Access Compliance Report Public Rights-of-Way (Curb Ramps)

Intersection ID: N/A	Main Street: REA_RD	Cross Street: FAIRWAYS_CLUB_DR	Location: NW
ADA ID: FB0EB1E4AF29	Ramp Type: PerpDiag	Initial Pass/Fail: Fail	Overall Compliance: No Severity Score: 21.25

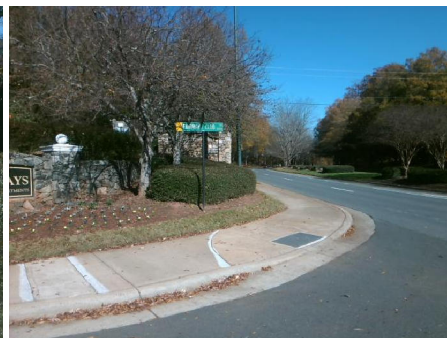
Not Found, R304.5.1, R304.2.2

Compliance	Description	Data	Compliance	Description	Data
N/A	Ramp Length (in)	87.0	No	Ramp Slope (%)	9.3
No	Ramp Width (in)	47.0	Yes	Ramp XSlope (%)	1.1
N/A	Flare Type LT	N/A	N/A	Flare Type RT	N/A
N/A	Flare Slope LT (%)	N/A	N/A	Flare Slope RT (%)	N/A
N/A	Flare Traversable LT?	N/A	N/A	Flare Traversable RT?	N/A
N/A	Landing Length (in)	N/A	N/A	DWS Provided?	N/A
N/A	Landing Width (in)	N/A	N/A	DWS Contrast?	N/A
N/A	Landing Slope (%)	N/A	N/A	DWS Length (in)	N/A
N/A	Landing X Slope (%)	N/A	N/A	DWS Full Width?	N/A
N/A	Landing Curb? (Y/N)	N/A	N/A	DWS Offset (in)	N/A
N/A	Shared Landing?	N/A			
N/A	Gutter Ponding?	N/A	N/A	Gutter Slope (%)	N/A
N/A	Gutter Lip Ht (in)	N/A	N/A	Gutter X Slope (%)	N/A
N/A	Painted X Walk1?	No	N/A	Painted X Walk2?	No
	X Walk 1 Direction	To S		X Walk 2 Direction	To E
N/A	X Walk 1 Width (in)	N/A	N/A	X Walk 2 Width (in)	N/A
	X Walk 1 Slope (%)	3.5		X Walk 2 Slope (%)	0.0
	X Walk 1 X Slope (%)	1.9		X Walk 2 X Slope (%)	5.3

Remove & Replace Curb Ramp With Two New Directional Ramps or Equivalent.
